ADDENDUM NO. 1

May 31, 2023

Noblesville Ambulatory Surgery Center
14065 Borg Warner Drive
Noblesville, IN 46060

1 FLOOR PLAN - LEVEL 1 - POWER - AREA A
A-E2.01A 1/8" = 1'-0"

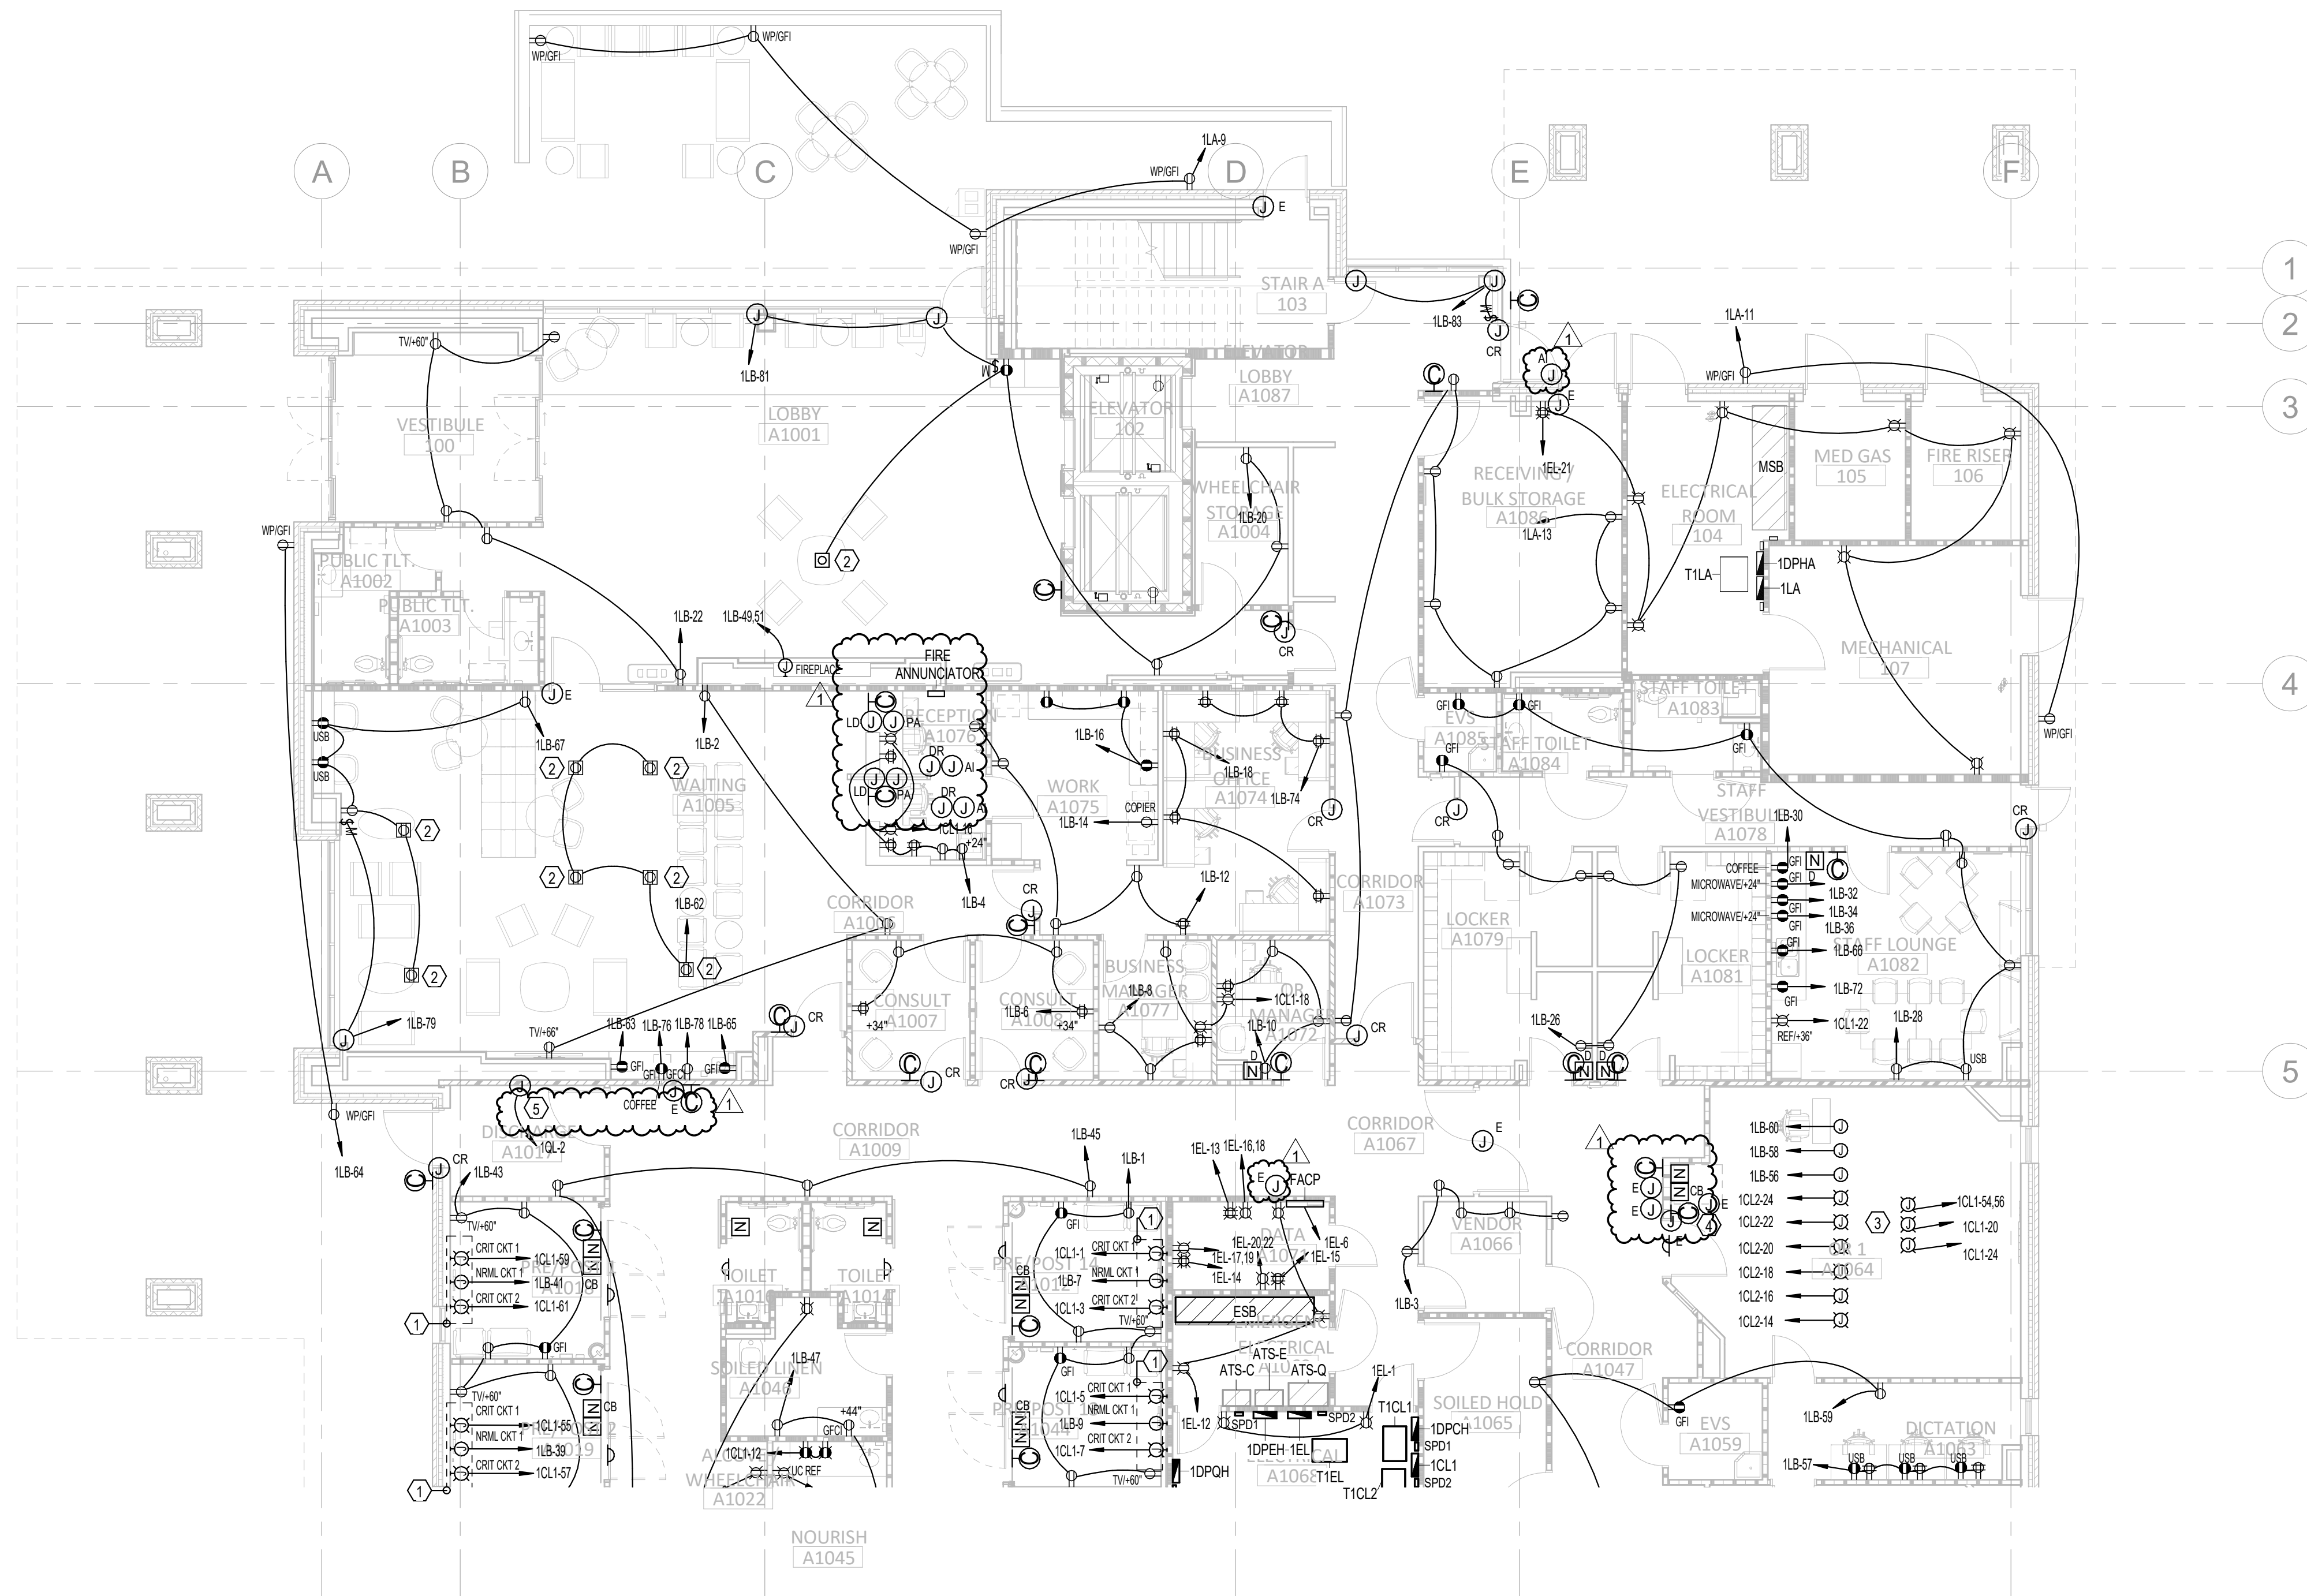
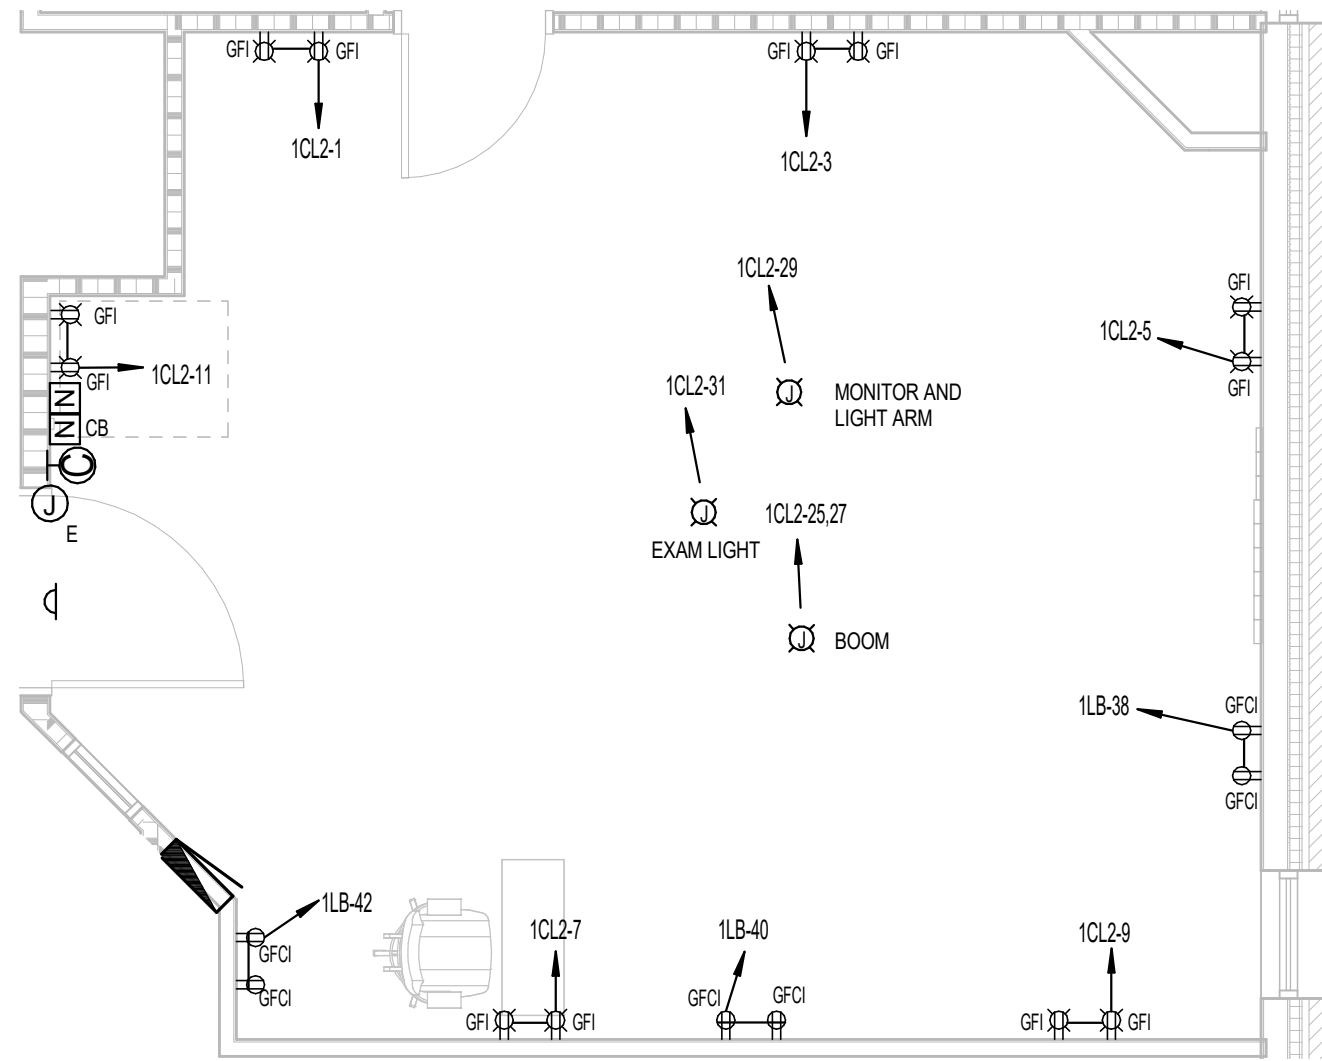
- A. Added keyed note 5.
- B. Added power for area smoke dampers.
- C. Added junction boxes for power to lock downs, panic alarms, door releases, door open buttons, and intercoms.
- D. Added GFCI general purpose receptacle in elevator pit.
- E. Removed (1) redundant clock and (1) card reader.
- F. Specified fire alarm annunciator panel location.
- G. Added note for clock power circuit.
